Permit of Authorization to Construct an On-Site Sewage Facility Permit Valid For One Year From Date Issued

Permit Number: 118336

30732 BLUEBERRY RDG CITY OF BULVERDE, TX 78163

Thank you for your submission. We have reviewed the planning materials for the referenced permit application, and unfortunately, they are insufficient. To proceed with processing this permit, we require the following:

SITE PLAN & OSSF DESIGN

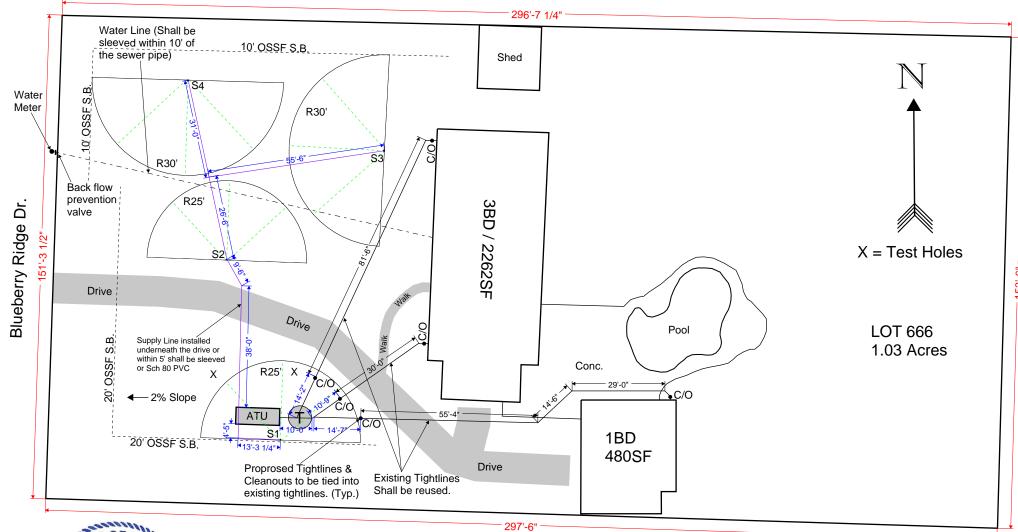
There appears to be adequate area to maintain the 20ft OSSF setback from edge of spray and property lines. What is the reason for the

encroachment?

A variance, to the rules in TAC 285, is requested to reduce the 20' setback from the property line to the edge of spray to 10'. The reason for the variance is due to the size of the lot, existing structures, and trees limiting the spray area for the surface application. To provide equivalent protection a battery backup shall be installed in the control panel to insure that the timer does not lose power and that the system sprays only between the hours of 12:00 AM & 5:00AM.
